s92 - Request for Further Information and Affected Party Approval

I have reviewed the resource consent application **RC245399** by Deg Tegh Fateh Sikh Society to establish a community facility (Sikh Temple) at 517 Hamptons Road, Rolleston. Following the receipt of the integrated transport assessment and noise assessment, the Council's technical reviewers have identified a range of matters that require clarification and/or comment.

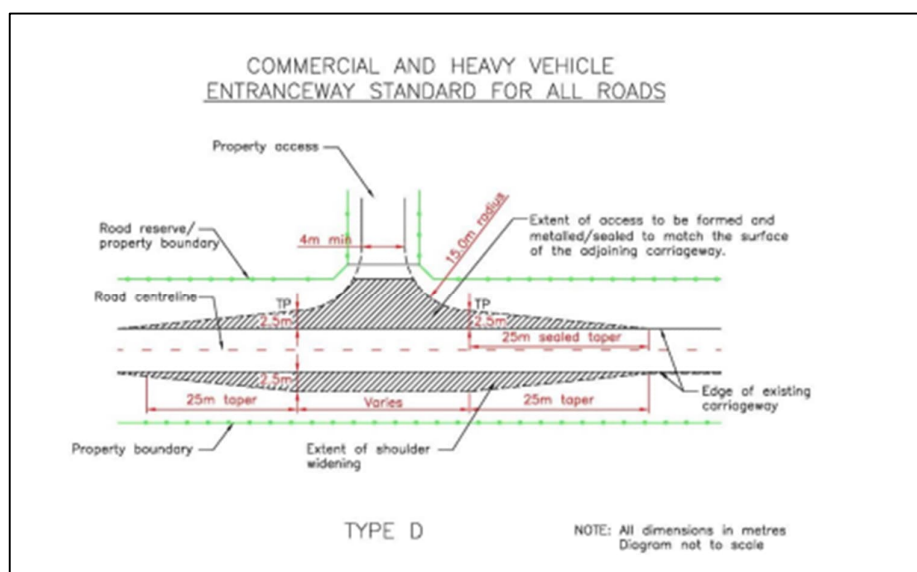
11. Please provide a safe systems assessment from a suitably qualified transportation engineer that addresses the following for the crossing on Waterholes Road.
12. Please provide commentary to address the safety issues related to the culvert (and associated headwalls) in proximity to the vehicle crossing.
13. Please provide further assessment to assess possible the vehicle crossing widening requirements of Diagram D (see below).
